Iowa Department of Transportation

MINUTES OF IOWA DOT SPECIFICATION COMMITTEE MEETING

October 13 2005

Figure 1
Clothing and equipment for daytime flagging operations

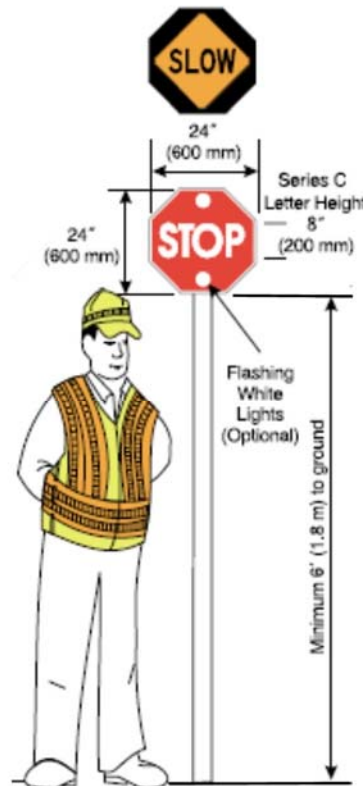
In addition to being dressed neatly, flaggers need to be dressed for safety. In particular, flaggers are required to be easily visible to traffic. **Flagger's shall Always** wear the following required items, even when serving as a replacement for a short period (see Figure 1):

- an ANSI 107 Class 2 vest, shirt, or jacket in yellow green, orange, or fluorescent versions of these colors (combinations of these colors are acceptable) and
- a soft cap in yellow green, orange, or fluorescent versions of these colors meeting ANSI 107 headwear requirements; combinations of these colors are acceptable. (A hard hat in the same colors is an acceptable alternative to the soft cap and may be required by OSHA or your employer in certain circumstances.)

Flaggers shall be equipped with the standard combination STOP/SLOW or SLOW/SLOW staff-mounted sign (see Figure 1). Retroreflective sheeting shall comply with applicable specifications. Optional but useful equipment and supplies include the following:

Figure 10
Clothing and equipment for nighttime flagging operations

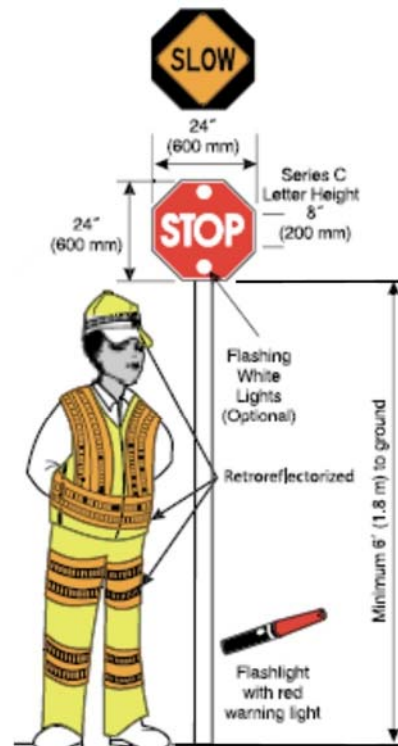
When flagging at night, **Flagger's shall** wear the following required items (see Figure 10):

- an ANSI 107 Class 2 retroreflectorized vest, shirt, or jacket and ANSI 107 Class E retroreflectorized pants in yellow green, or orange, or fluorescent versions of these colors (combinations of these colors are acceptable), and
- a retroreflectorized soft cap in yellow green, or orange, or fluorescent versions of these colors meeting ANSI 107 headwear requirements; combinations of these colors are acceptable. (A retroreflectorized hard hat in the same colors is an acceptable alternative to the soft cap and may be required by OSHA or your employer in certain circumstances.)

At night, flaggers shall be equipped with the following (see Figure 10):

- retroreflectorized signs and other devices (retroreflective sheeting shall comply with applicable specifications),
- flashlight with nose cone, lantern, or other lighted signal that will display a red warning light, and
- a lighted flagging station (see Figure 11).

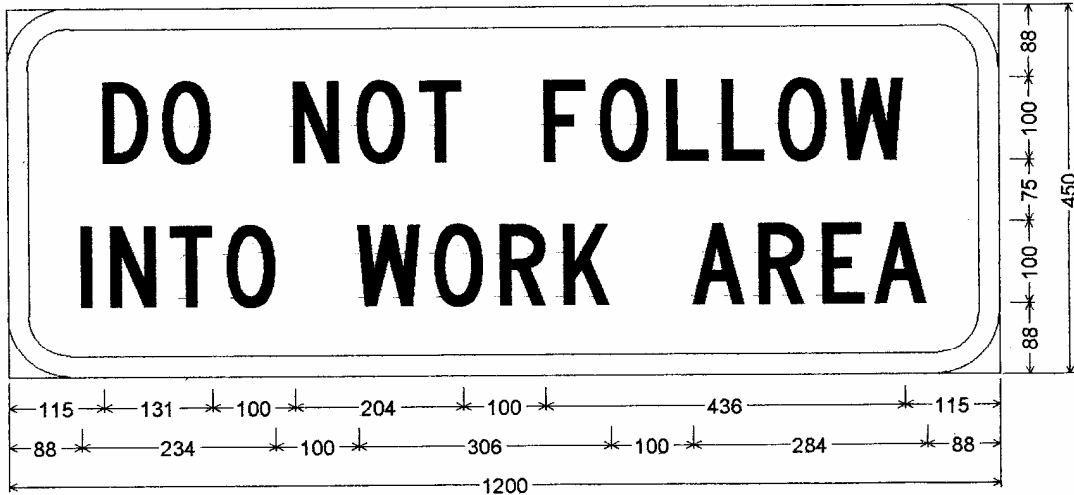
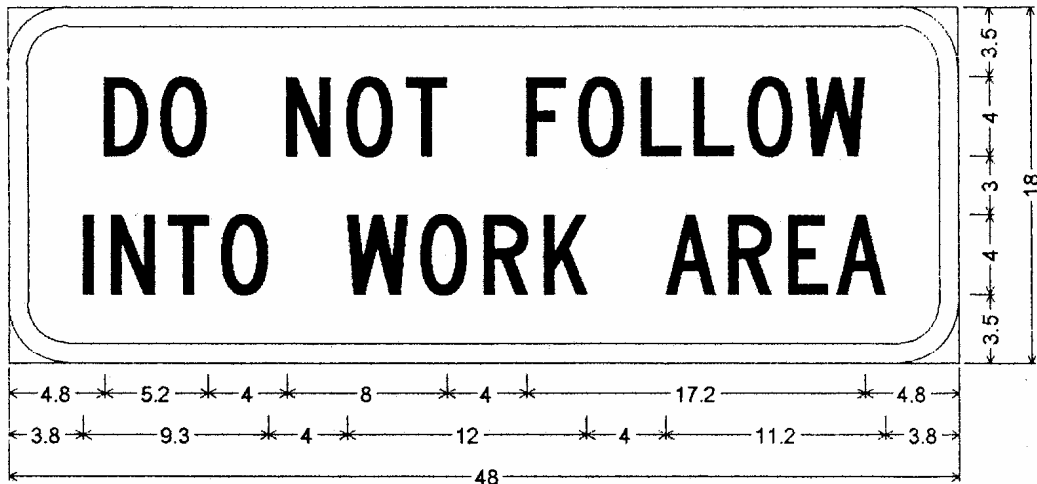
All vehicles hauling material to or from the work area shall display an 18 inch by 48 inch (450 mm by 1200 mm) sign with the legend "DO NOT FOLLOW - INTO WORK AREA" as shown below. The sign shall be orange with black lettering using Type VII (Iowa) sheeting. The sign shall be kept clean in order to maintain its visibility.
